Standards Committee

Meeting Agenda

Wednesday, July 5, 2023, at 9:00am

TITLE	Champion
<p>2nd time to Committee. Discussed in May.</p> <p>Twenty (20) proposed drawings and revisions to WVDOH Standard details Book – Volume 2. The sheets are listed below. A summary of each sheet’s revisions are included in the meeting packet; and proposed sheets have revised areas highlighted yellow.</p> <ul style="list-style-type: none"> a) <i>TE1-3A Roadside Sign Supports Steel Beam Type</i> b) <i>TE1-3B Roadside Sign Supports Steel Beam Type</i> c) <i>TE1-3C Roadside Sign Supports Steel Beam Type</i> d) <i>TE2-1A Bridge or Retaining Wall Sign Mounting, Type K 1 & 2 Supports</i> e) <i>TE2-1B Bridge or Retaining Wall Sign Mounting, Type K 1 & 2 Supports</i> f) <i>TE2-2 Bridge or Retaining Wall Sign Mounting, Type L Pipe Post Mount</i> g) <i>TE2-3 Barrier Wall Sign Support Bracket Type D</i> h) <i>TE3-1 Overhead Sign Support – Steel Two Tube Span (TTS)</i> i) <i>TE3-2 Overhead Sign Support – Steel One Tube Span (OTS)</i> j) <i>TE4-3A Overhead Sign Support – Steel Double Arm Cantilever</i> k) <i>TE4-3B Overhead Sign Support – Butterfly Cantilever</i> l) <i>TE4-4A Overhead Sign Support – Single Arm Ca

STANDARD SHEET TE4-3A

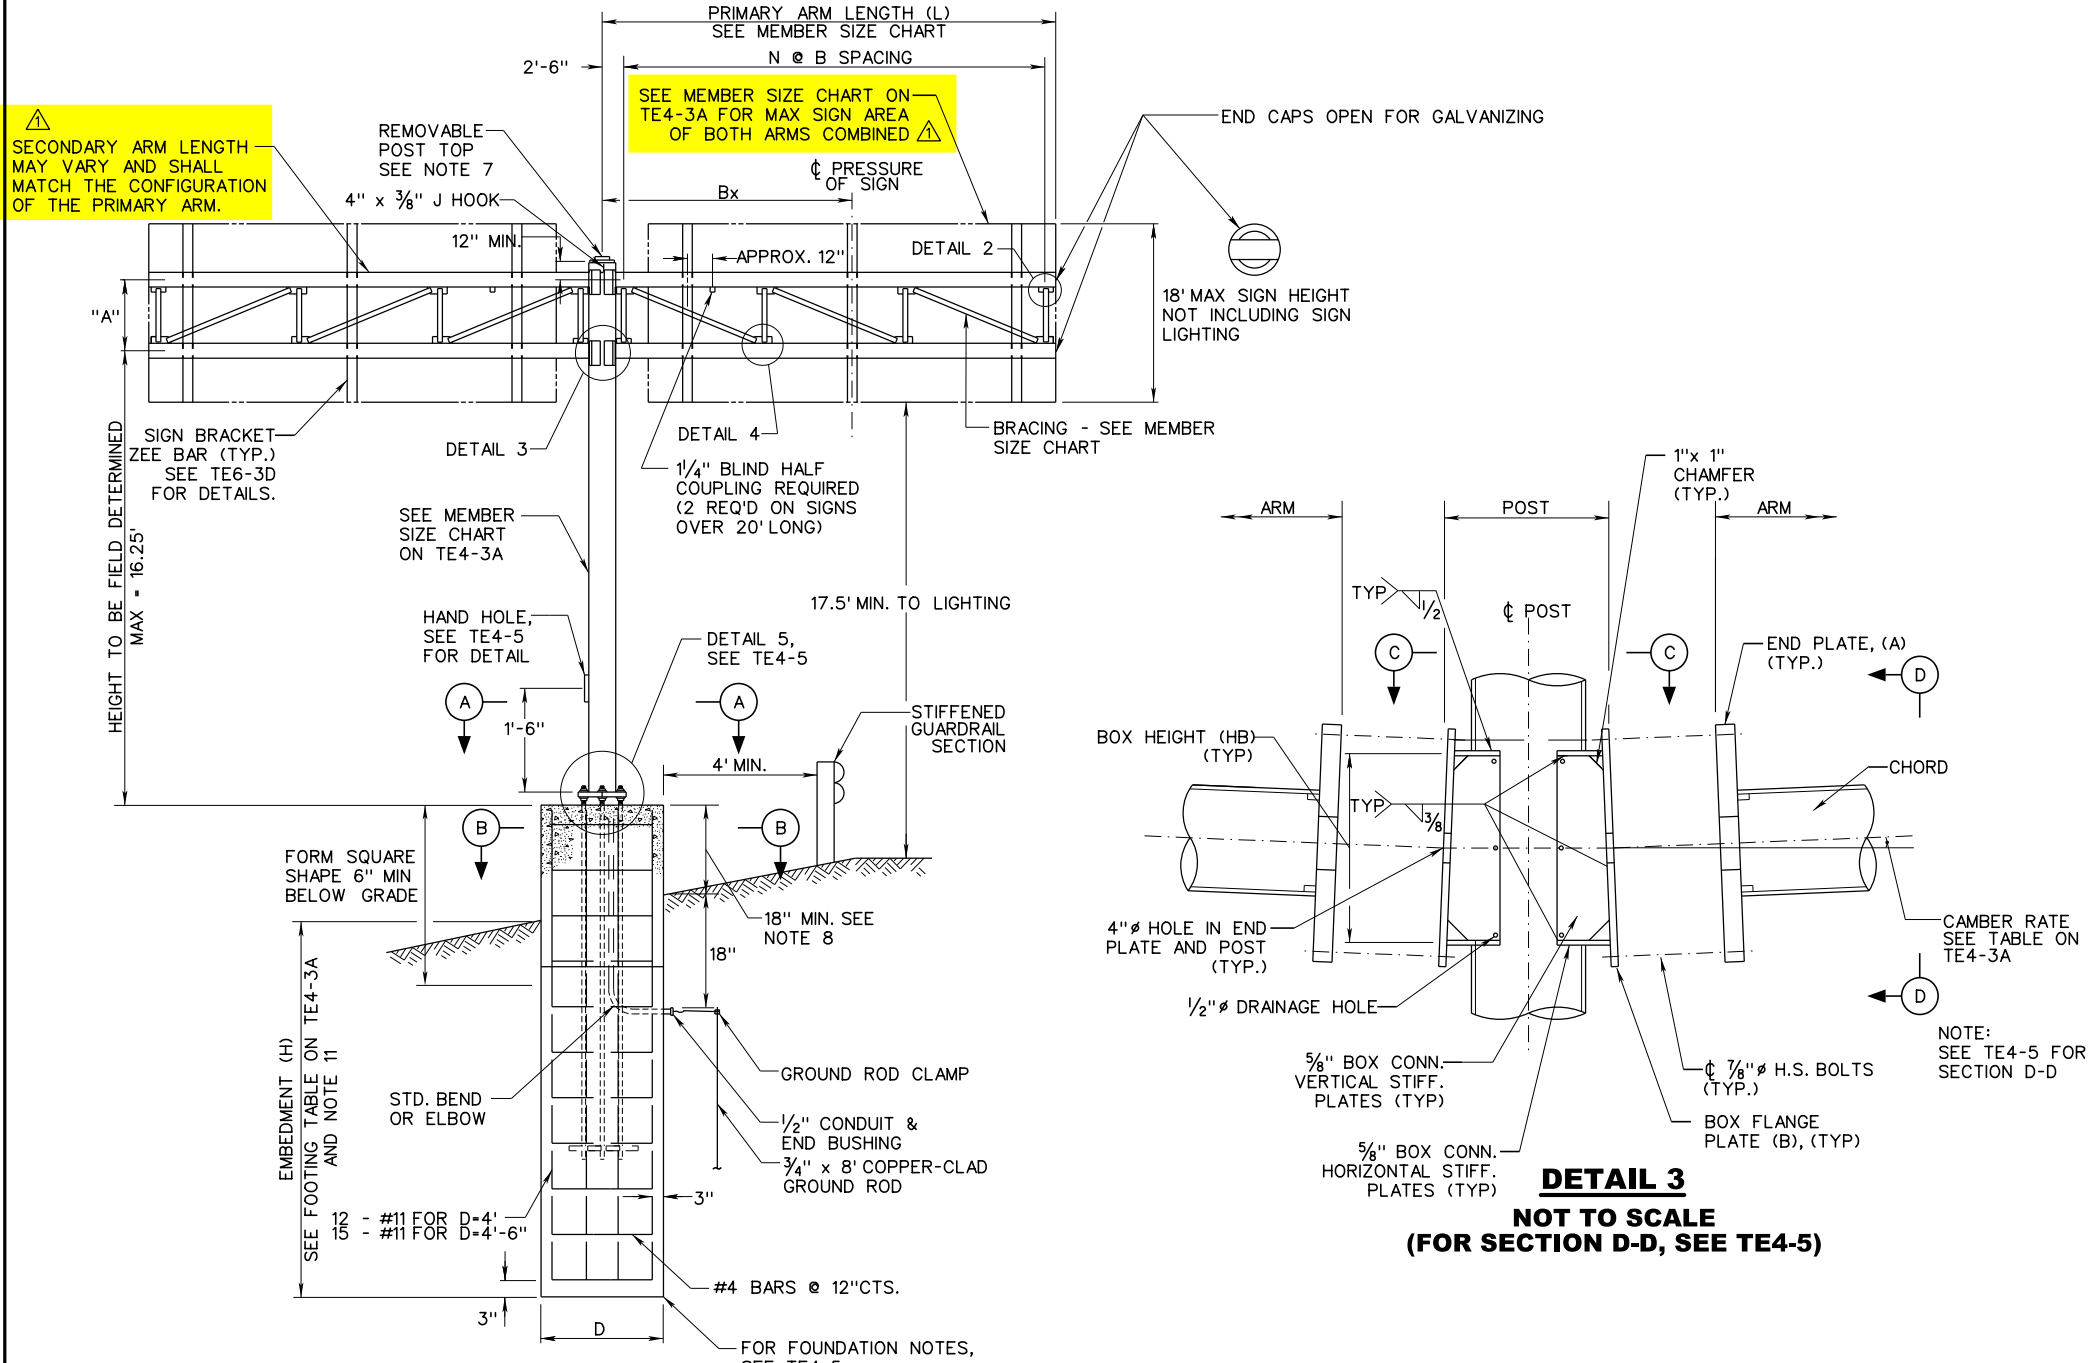
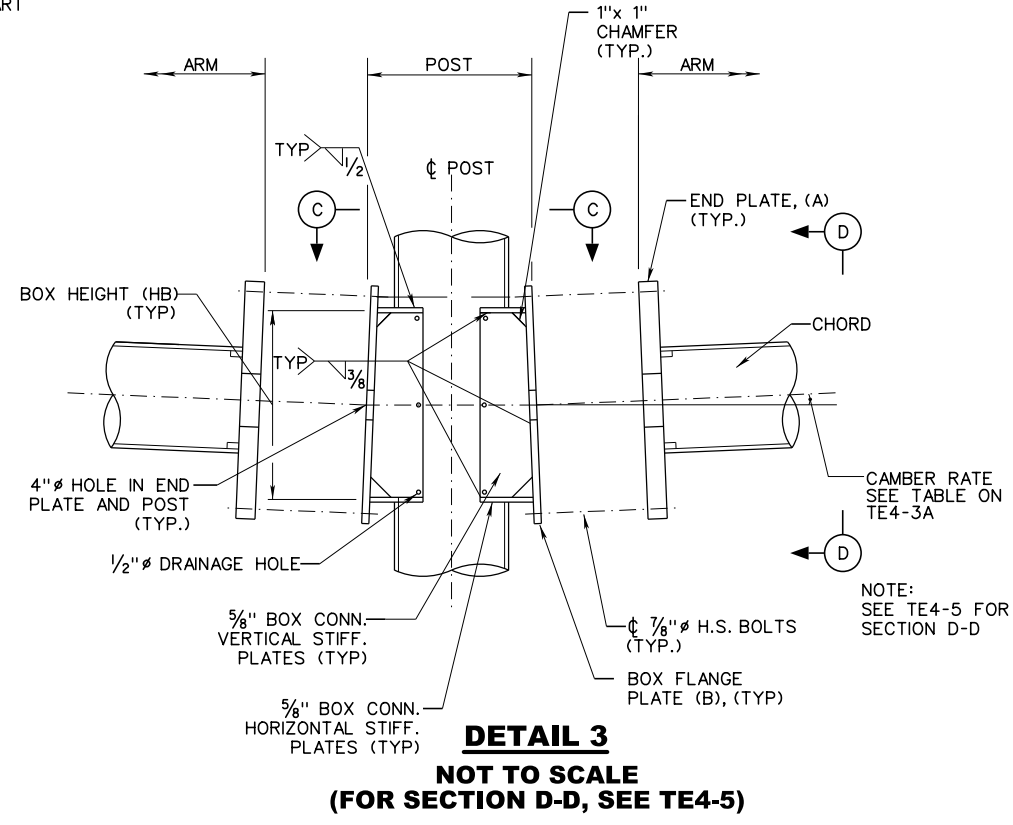
TE4-3A	1	2/22/2023	Added NPS to column headings and changed post to NPS in Member Size Chart. Revised plate dimensions and added max plate hole diameter to Footing Table. Revised end and box flange plates, revised bolt numbers for DAC-32 & DAC-40, and added Hole Diameter column to Box Connection Table.

STANDARD SHEET TE4-3B

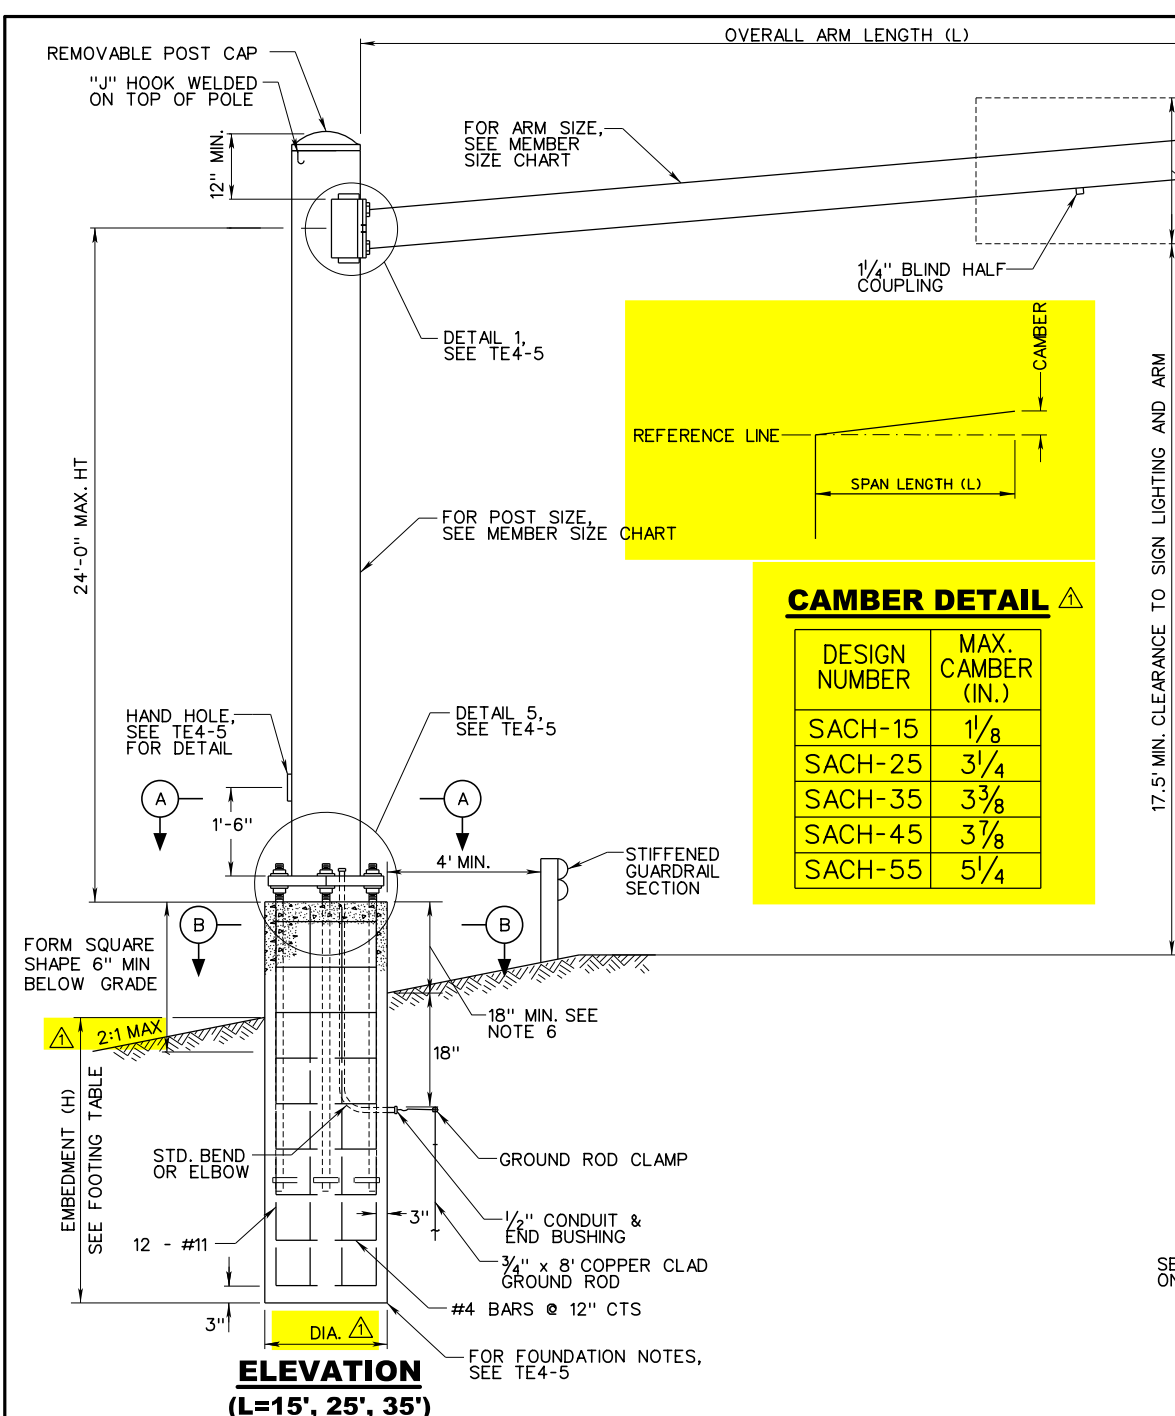
TE4-3B	1	2/22/2023	Revised rules for allowable sign area and secondary arm member sizes. Original version allowed max sign area for each arm, but that is incorrect.
TE4-4A	1	11/18/2022	Revised foundation diameter and embedment depth; moved diameter information to new column in Footing Table. Added design soil parameters and 2:1 max slope to Elevations. Added 'W' dimension to the Box Connection Table for SACH-15, 25 & 35 designs. Increased post sizes for SACH-45 & 55 designs in the Member Size Chart and corrected arm sizes in the Box Connection Table. Added base plate hole diameter column to Footing Table. Added camber information.
TE4-4B	1	9/2020	Added Moment Arm Calculation to aid in determining proper design for multiple smaller signs. Revised bolt hole diameter in the Footing Table. Added 'W' dimension and 'X' dimension (TE4-5) to the Box Connection Table. Added camber angle.
	2	5/2022	Revised Arm A and Arm B lengths and added Arm B diameters in Member Size chart.

FOR EXAMPLE, A BC-32-16 WOULD HAVE A PRIMARY ARM 32 FEET IN LENGTH AND A SECONDARY ARM 16 FEET IN LENGTH. IT WOULD HAVE A 30 INCH DIAMETER POST AND BOTH ARMS WOULD HAVE 16SCH40 CHORDS, 4SCH40 BRACING, AND 'A' DIMENSION OF 6'-0". THE TOTAL AREA OF SIGNS ON BOTH ARMS COMBINED CANNOT EXCEED 450 SF.

OVERHEAD SIGN SUPPORT-STEEL
SINGLE ARM CANTILEVER (HEAVY)
STANDARD SHEET TE4-4A

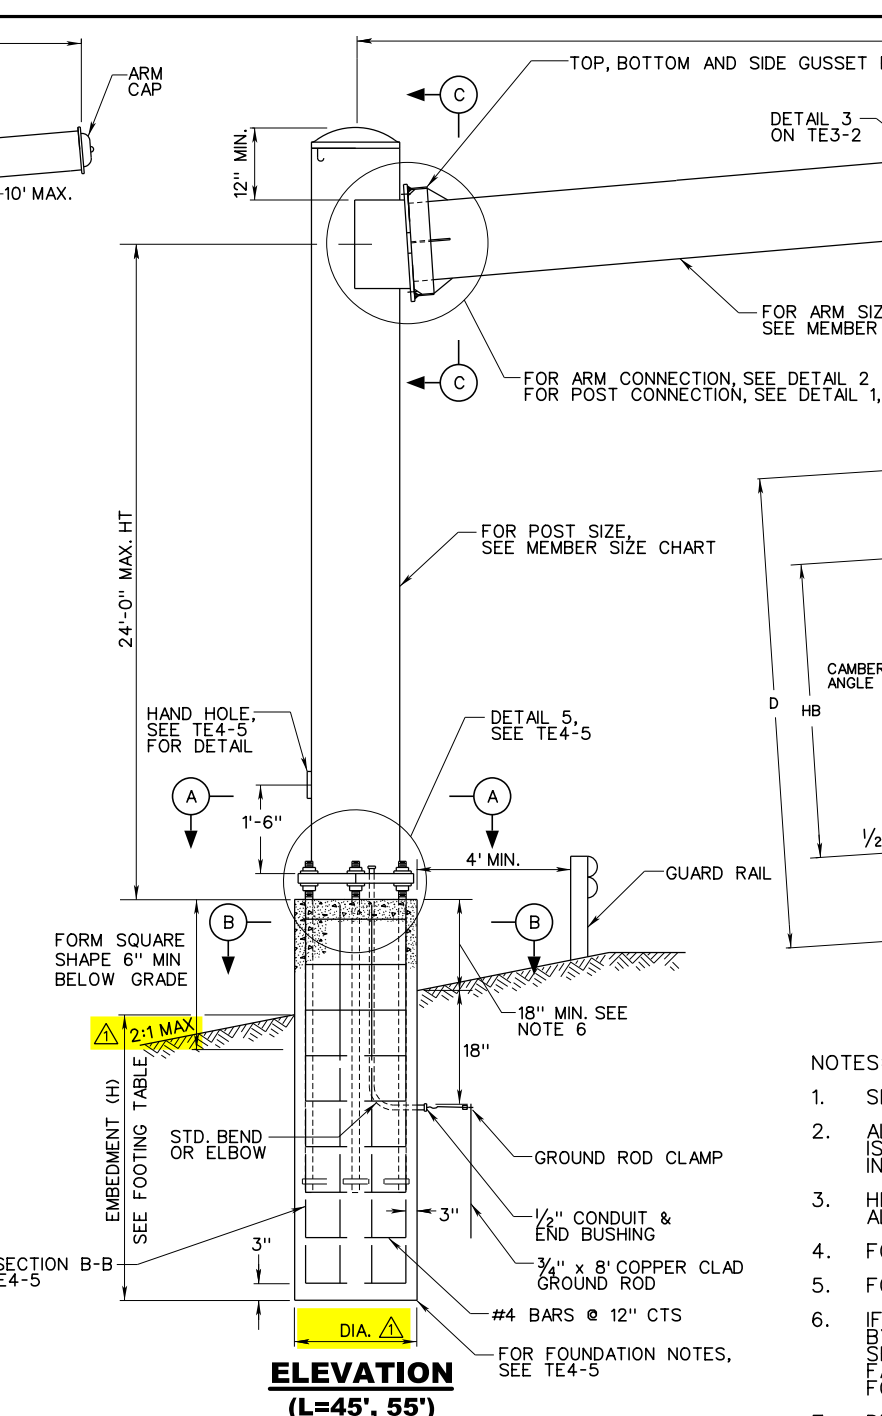
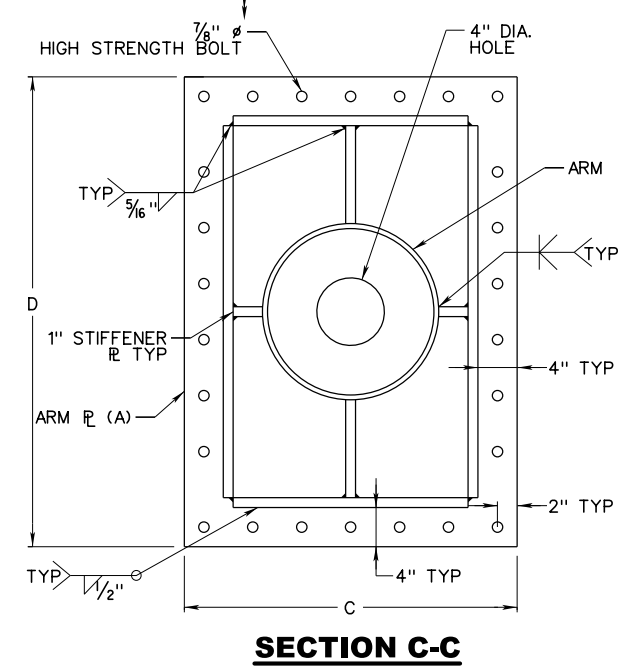
REVISED FOUNDATION DIAMETER AND EMBEDMENT DEPTH FOR 45' & 55' ARM LENGTHS. ADDED SOIL PARAMETER NOTE AND 2:1 MAX. ALLOWABLE SLOPE TO ELEVATIONS. REVISED BOX CONNECTION TABLE TO ADD W DIMENSION. REVISED POST AND ARM SIZES FOR 45' & 55' ARM LENGTHS AND AFFECTED BASE PLATE DIMENSIONS. MOVED FOOTING DIMENSION INFORMATION TO THE CHART. ADDED BASE PLATE HOLE SIZE INFORMATION. ADDED CAMBER DETAIL AND CHART.

OVERHEAD SIGN SUPPORT-STEEL
SINGLE ARM CANTILEVER (LIGHT)
STANDARD SHEET TE4-4B

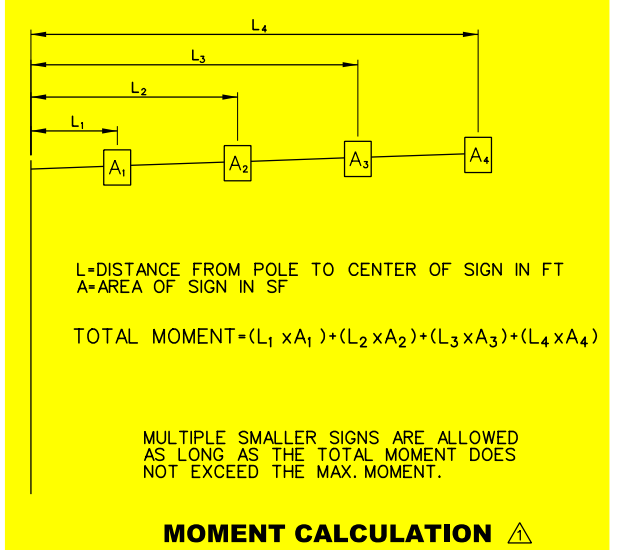
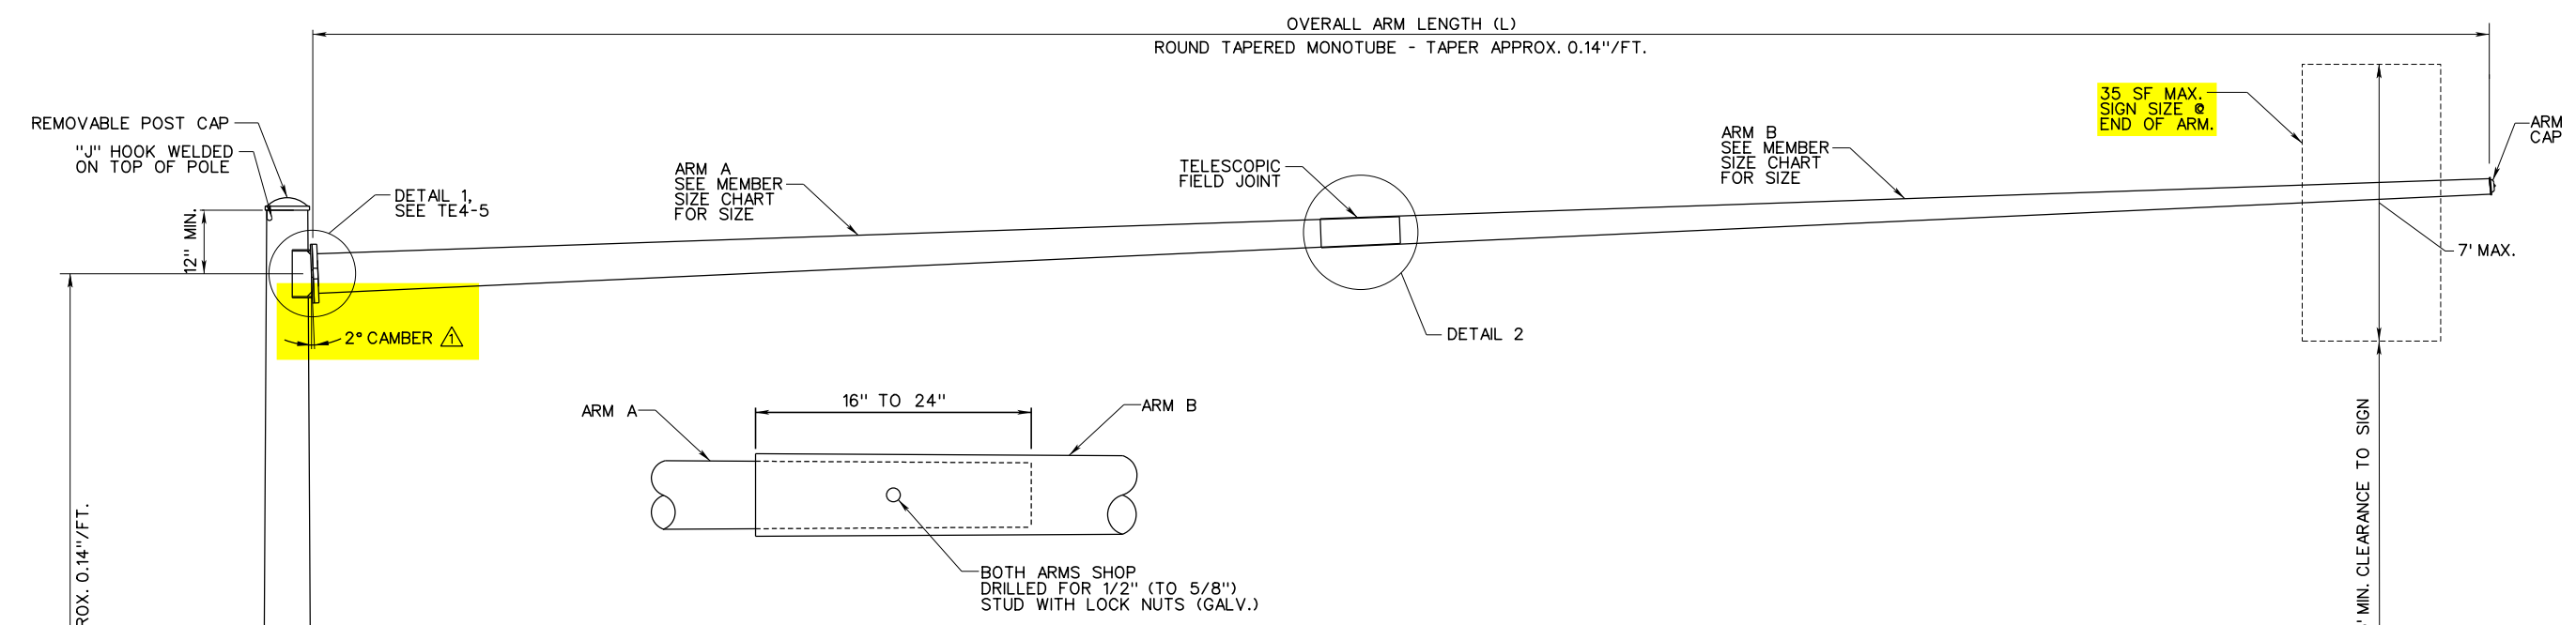
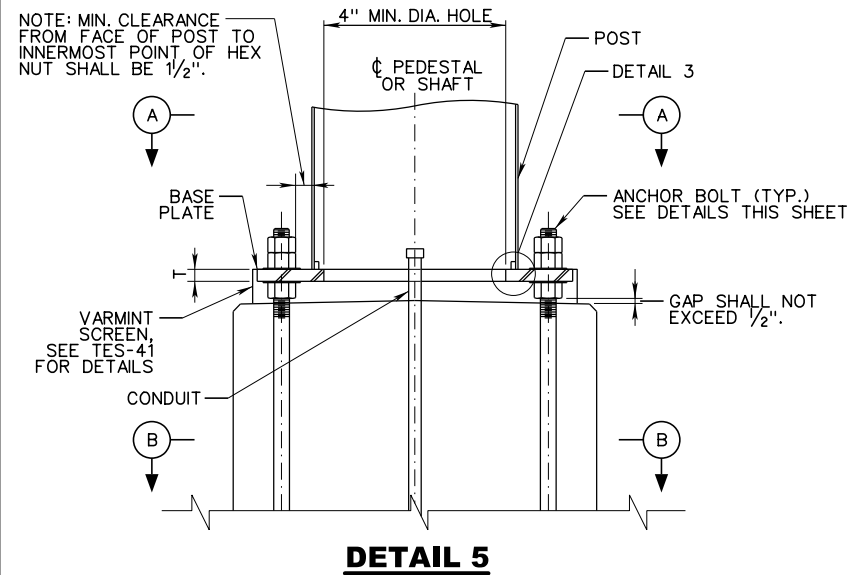
Δ ADDED MOMENT ARM CALCULATION, REVISED PLATE HOLE DIAMETER, ADDED W DIMENSION TO TABLE, ADDED CAMBER ANGLE.
 Δ REVISED ARM SIZES.
